INDESIT company

Model type:
AVXXL129EX

Commercial code:
F033725

n1040398: Programme keys aligned.

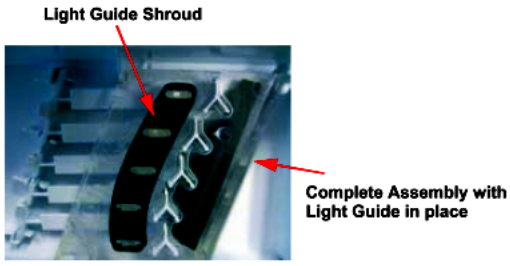
From serial no. 51118.0001, a specially shaped foam pad has been inserted between the keypad and light guide on washing machines AVXXF and AVXXL and washer-dryers AMFFX and AMXXL. The part code of this new component is C00142393 (fig. 001).

This new part separates the keys and pushes them outwards together to ensure they are perfectly aligned.

The pictures in figures 002 and 003 illustrate how the foam pad should be fitted on the keypad and subsequent assembly of the light guide with relative light guide bracket, code C00142648.

The new parts C00142393 and C00142648 can also be used on premodification appliances.

n4008c02: Rear drum replacement

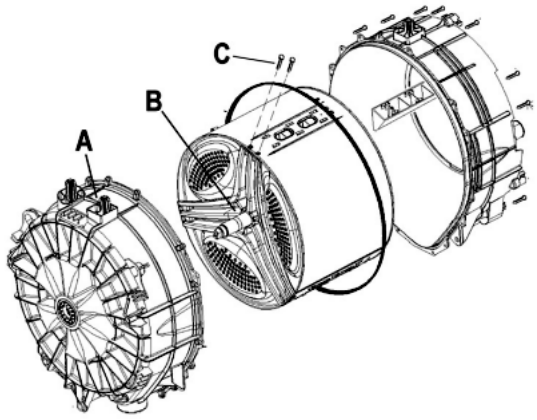
All drum service replacements use 35mm bearings

When you use in assistance the rear drum you will also need to change the drum bearing spider from the 30mm version to the 35mm version

A = C00119357 Drum Rear
B = C00117329 Drum Bearing Spider
C = C00201310 Drum Bearing Spider screws (Qty 6)

Production use 3 screws but for Service we suggest that 6 screws are used.

n0508c01: Door Gasket Clamp Band

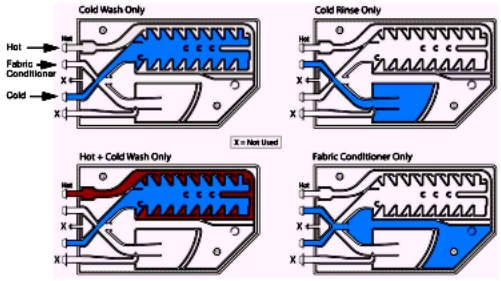
A New Polypropylene Gasket clamp band has been introduced in production from Serial number 80325.0000
The purpose is to provide added support to the inner rim of the door gasket.
